**CITY OF LINO LAKES
PLANNING & ZONING BOARD MEETING**

REQUEST: **CONTINUED PUBLIC HEARING** for Love to Grow On (6499 Lakota Trail)
 1. Conditional Use Permit
 2. Site Plan Review
 3. Variances

Re: *Love to Grow On - Resubmittal*
CUP, Variance and Site Plan Review
WSB Project No. 011428-000

GRADING, DRAINAGE AND
 EROSION CONTROL PLAN
 CITY OF LINO LAKES, MINNESOTA

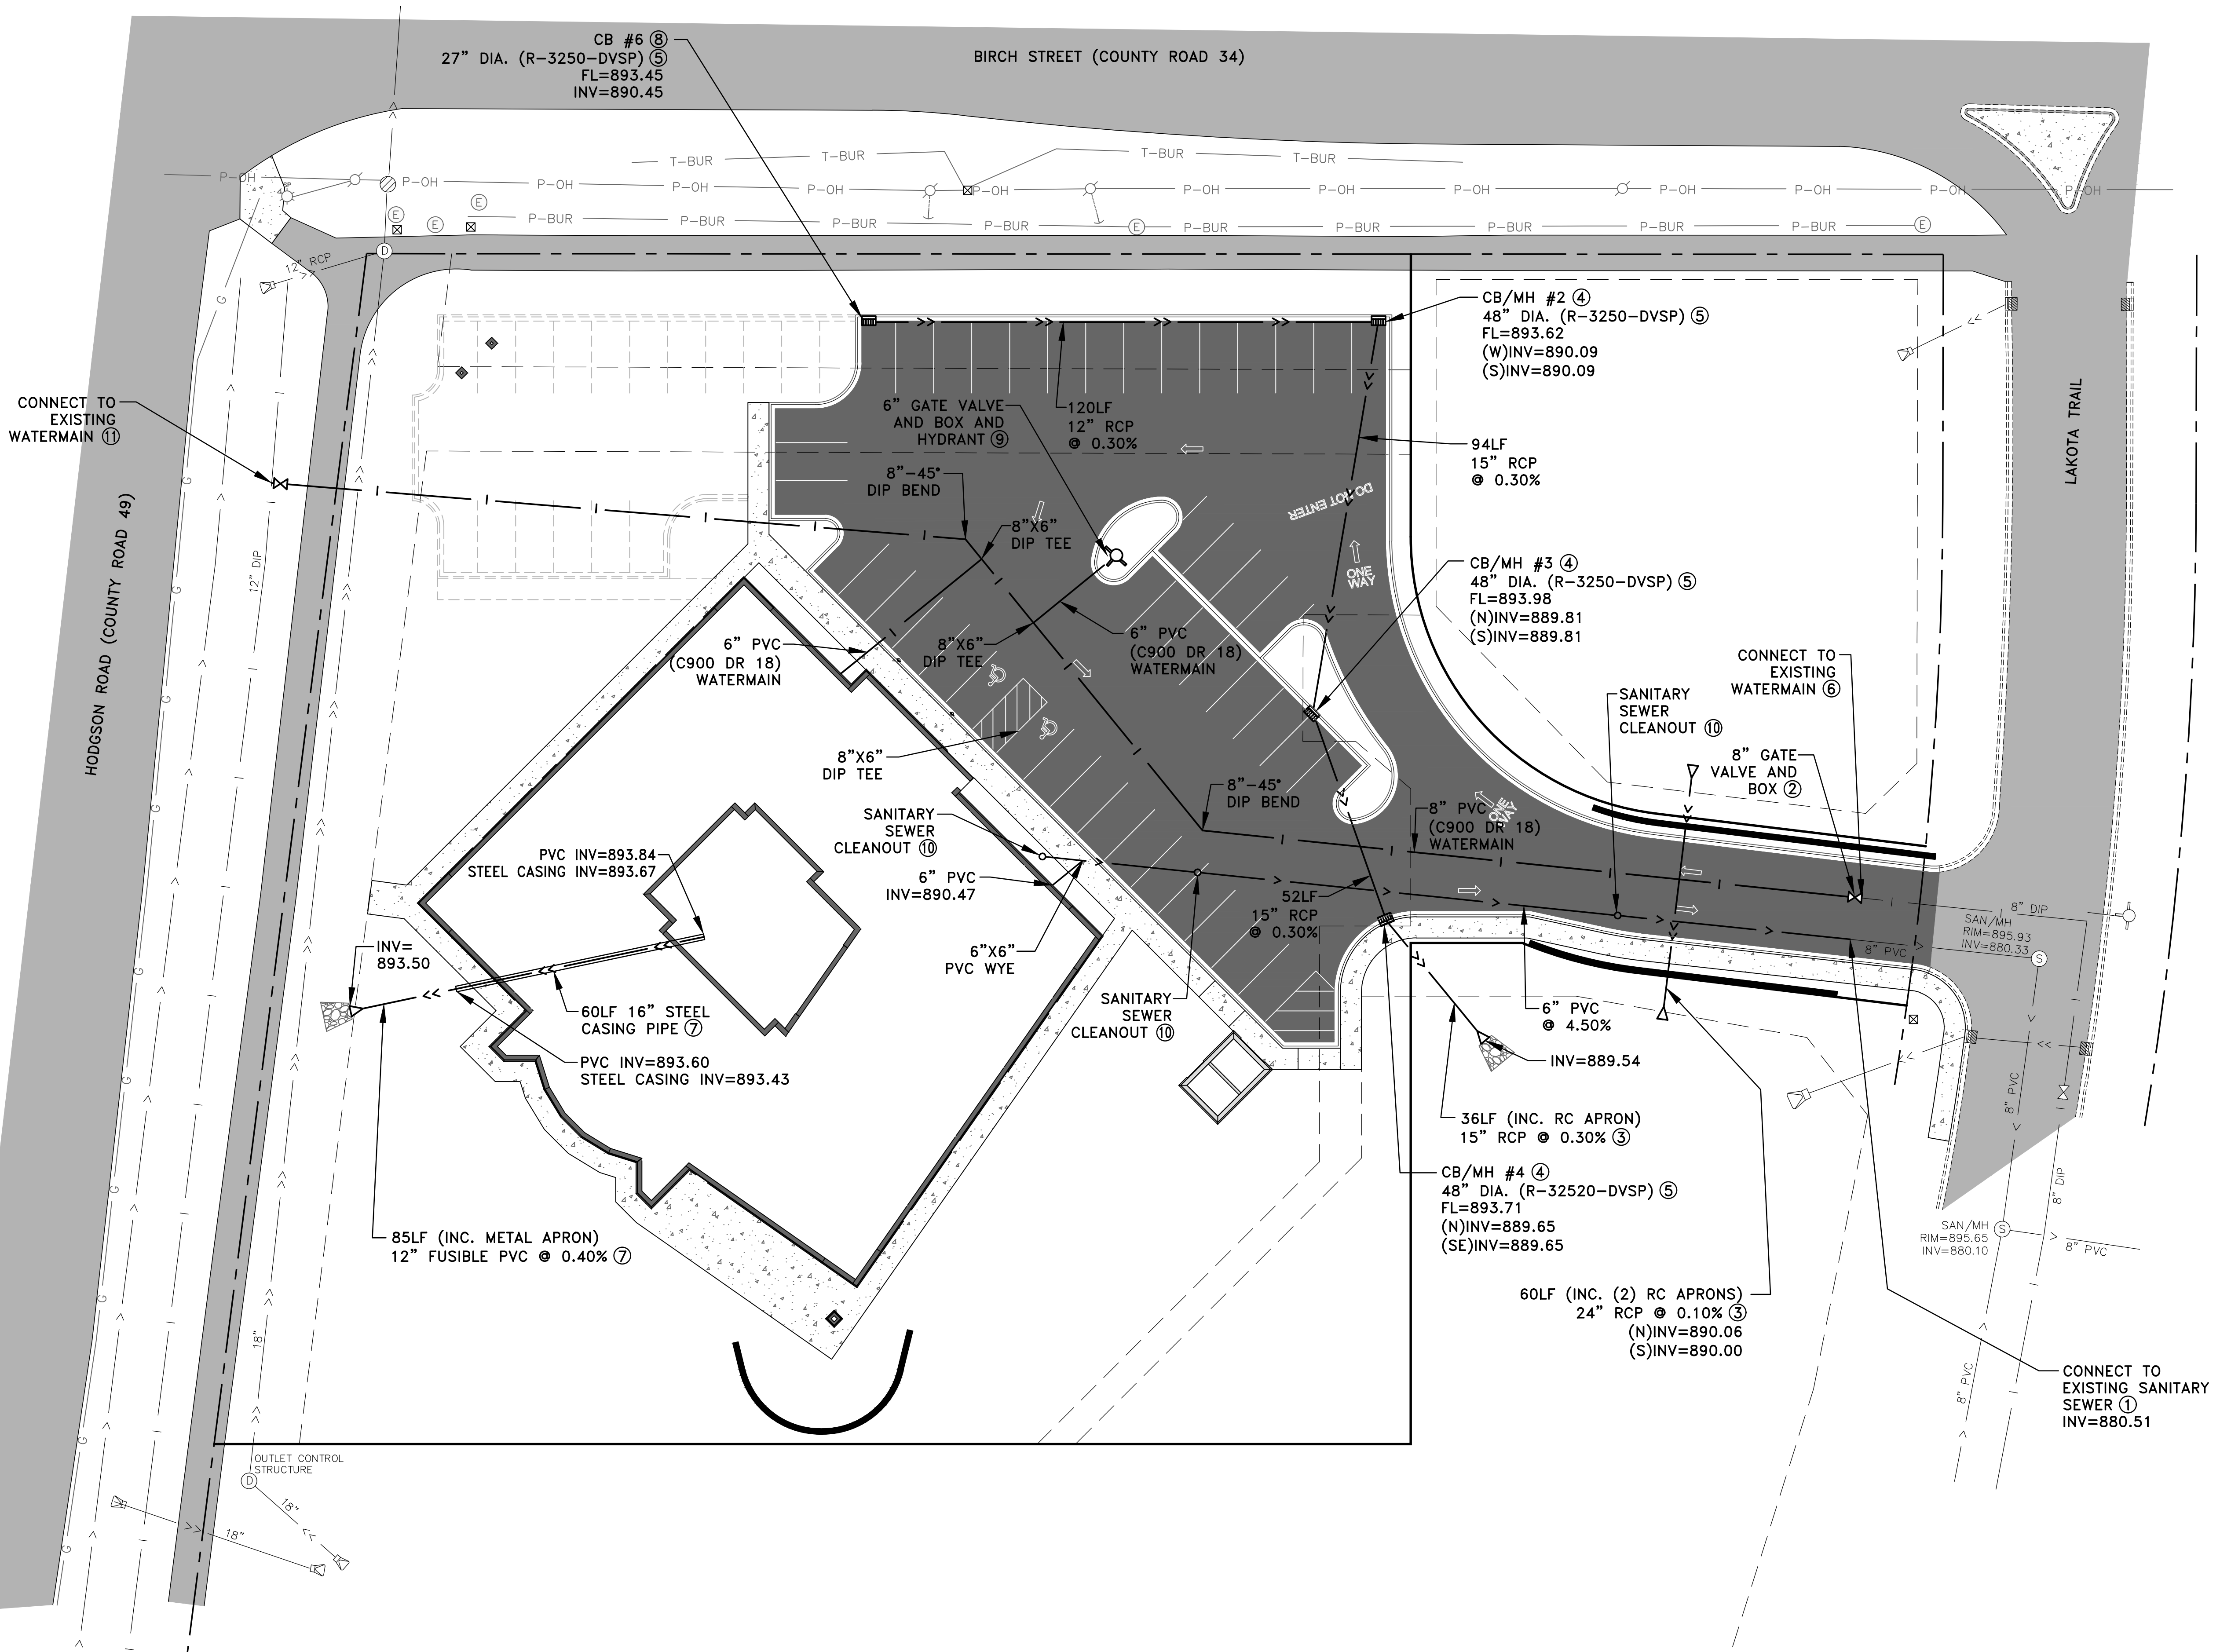
- ~~1. The applicant shall submit the earthwork volume data for excavation and embankment.~~
- ~~2. Parking lot grades should be shown on the plans. Parking lot grades should range between 2% and 5%.~~
- ~~3. The plans should indicate the vertical/horizontal datum and benchmark used on the title sheet.~~
- ~~4. We recommend including inlet protection on the exiting CB on the north bound side of Lakota Trail, just across from the site entrance.~~
- ~~5. The project calculations that should be provided are: total disturbed, pre-impervious calculations, post-construction impervious calculations.~~
- ~~6. The plans should include estimated quantities for sediment and erosion control BMPs used during the life of the project.~~
7. All grading and erosion control comments have been satisfactorily addressed. (04/05/18)

2. Include a 4-foot sump on CB # 4 to provide pre-treatment to the surface water prior to discharge to the infiltration trenches.
- ~~3. Lower the invert of CB #4 to 893.50 to bring the cover over the pipe closer to 2-feet.~~

6. The development was revised, lowering the FFE to 895.9, eliminating one infiltration basin and all infiltration trenches under the parking area. Applicant has demonstrated sequencing of stormwater infiltration design and has obtained a CAPROC from the RCWD.
7. Items 2 and 3 have not been addressed in 3/23/18 resubmittal. (04/05/18)

SHEET C8 OF C8 SHEETS

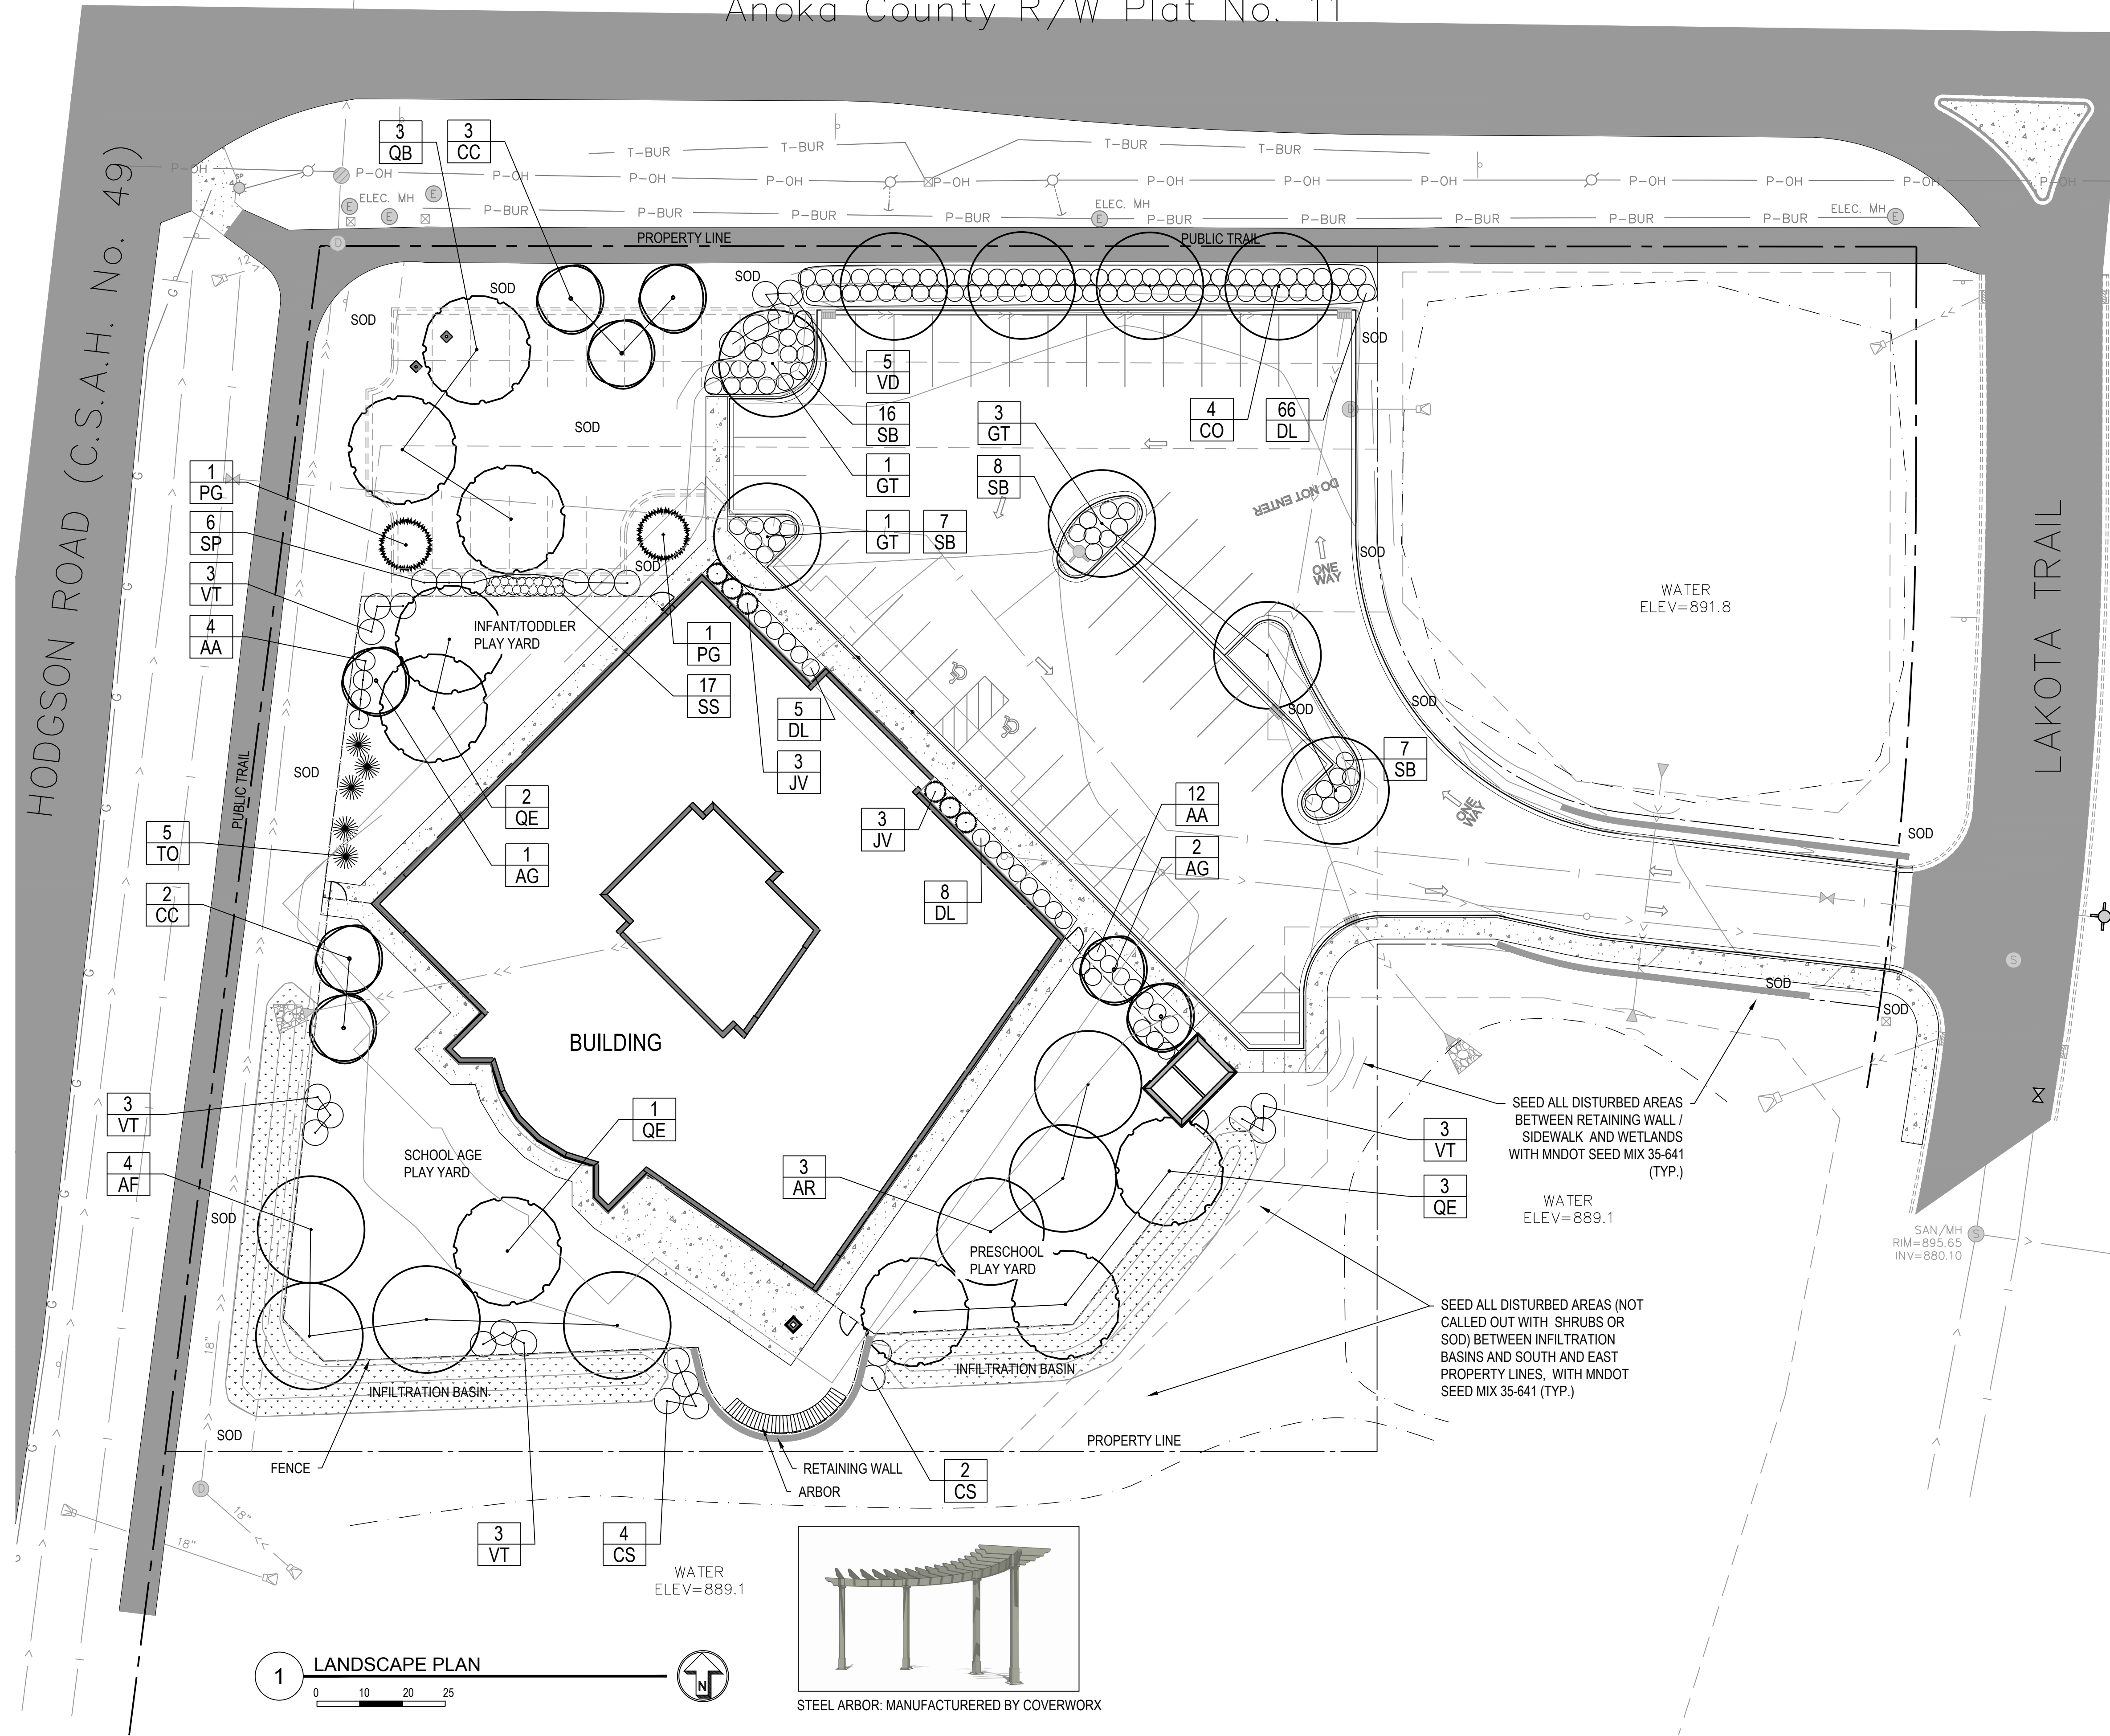
- ~~1. The applicant may need to loop the 8-inch diameter watermain through the site to Hodgson Road to provide adequate fire flow and pressure to the proposed building.~~
- ~~2. Sheet C8, Reference Note (2) shall read, "FIELD VERIFY EXISTENCE OF 8" GATE VALVE AND BOX, CONSTRUCT PER CITY DETAIL WAT 2 IF ABSENT."~~
3. All water supply comments have been satisfactorily addressed. (04/05/18)

- ~~1. Sheet C8, Reference Note (1) shall also include, "CONTRACTOR TO PROVIDE PVC REDUCER AS NECESSARY."~~
 - ~~a. Sheet C8, Reference Note (10) shall reference "SAN 5" in place of "SAN 6".~~
- ~~2. Sanitary sewer services shall be Schedule 40 pipe.~~
- ~~3. The applicant shall add a note that sanitary services require the contractor to provide X, Y and Z GPS coordinates of wyes and service ends for future locating requirements.~~
- ~~4. The applicant shall add a note that sanitary sewer pipe be installed with a tracer wire. A tracer wire box shall be provided at the surface for the ends of the sanitary sewer service tracer wire to provide access to wire ends for future locating requirements.~~
5. We recommend the sanitary sewer service be lowered to maintain 7.5 feet of cover and thus reducing the grade of pipe.
